METROPLAN

June 9, 2016

RE: I-30 Crossing Public Meeting #6  
Comments  
Submitted Via Email

**Area Wide Freeway Study – 2025 Time Horizon (LOS D achieved for all freeways but I-630)**

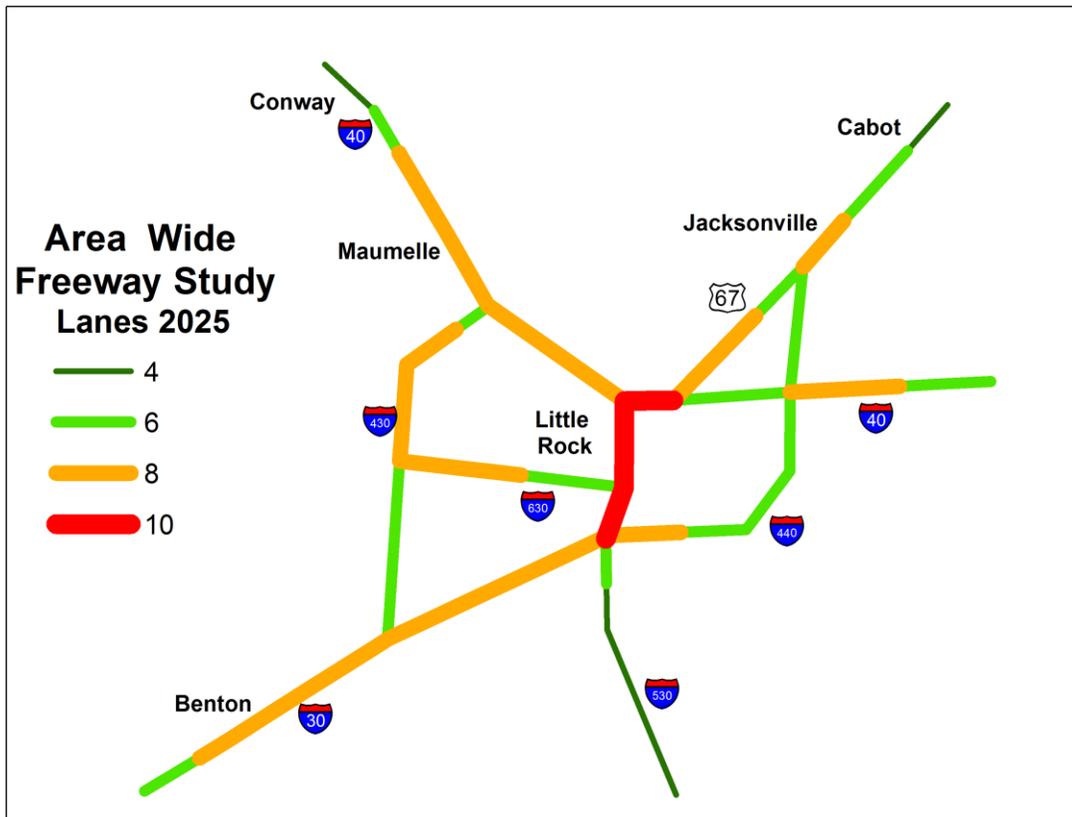
Phase II of the study, predicated on the LOS D performance standard, recommended a series of phased widenings by 2025 that would expand the regional freeway network to 8-10 lanes (see map below).
